Burlington Planning Commission

Special Meeting- Work Session

II. Proposed CDO Amendment- Downtown Mixed Use Core Overlay

TO: Burlington Planning Commission
FROM: David E. White, AICP, Director of Planning & Zoning
DATE: Friday, June 03, 2016
RE: Proposed DMUC Overlay

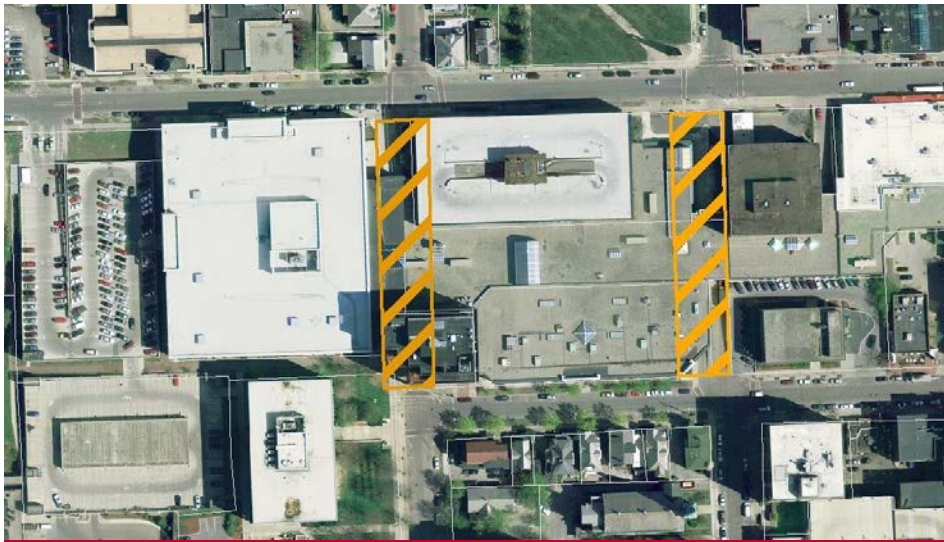
Commented [DEW1]: This will ensure that the proposed north-south connectivity on Pine and St. Paul streets envisioned in planBTV is accomplished. The City will have 120-days to initiate proceedings to acquire any land within this area that may be proposed for new development. As proposed, the BTC will comply.

Commented [DEW2]: These proposed new ROW's are consistent with the BTC project as proposed

Figure 4.4.1-2 Measuring Height Limits for Church Street Buildings

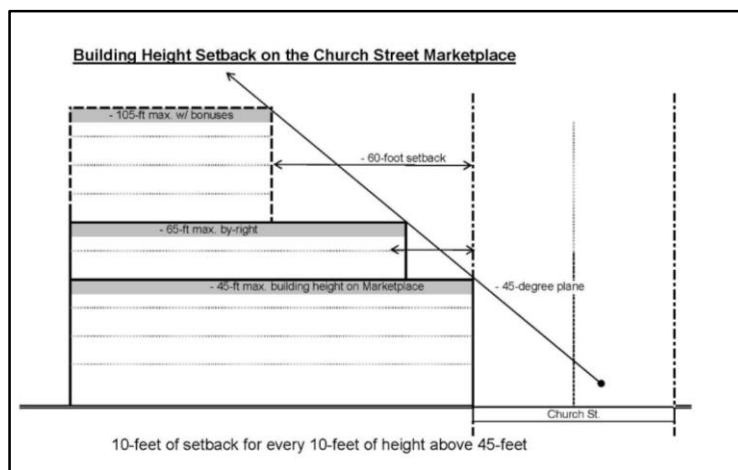
Commented [DEW3]: While outside of the proposed new overlay, this change is already envisioned as part of the currently proposed form-based code to provide better compatibility of building heights on Church Street. The BTC project as proposed will need its upper floors to be set back farther in order to comply

Successful integration of parking structures

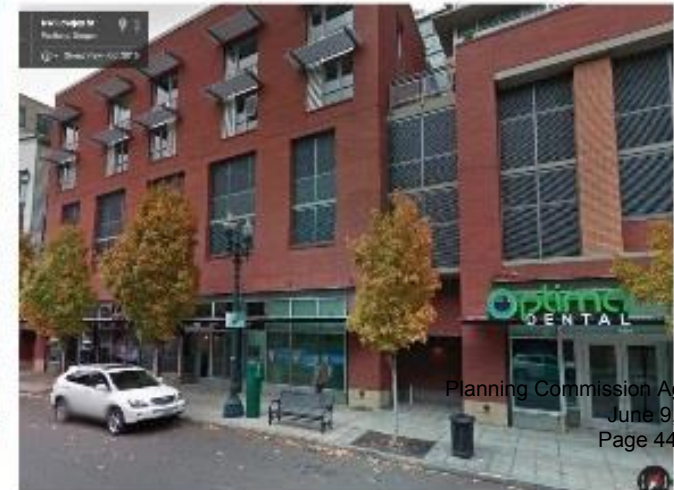
Key areas for future design development: Treatment of parking facades

- Design of parking facades:
 - Integrate/blend within overall building design
 - Vary expression within facades and on different streets

From Champlain College...before (top), after (bottom).

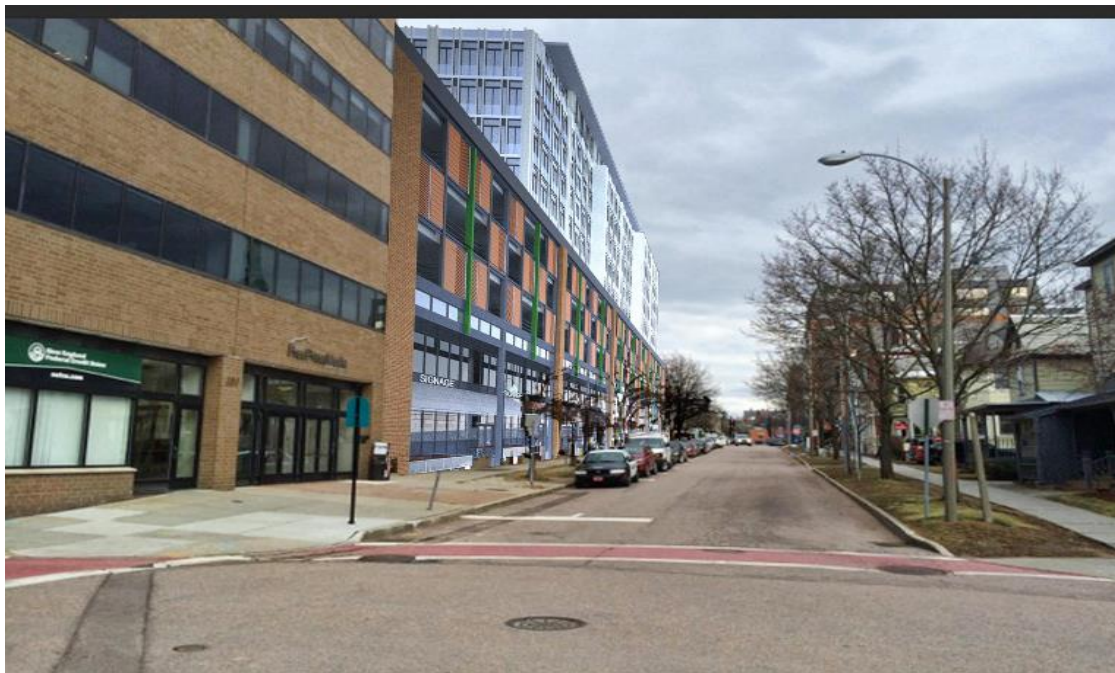
Below are images “before and after” completion of the proposed project, which has a height of 160 feet, 52% higher than the present maximum. To me these show a large scale deterioration of the visual connection I’ve mentioned-an assault on it, actually.
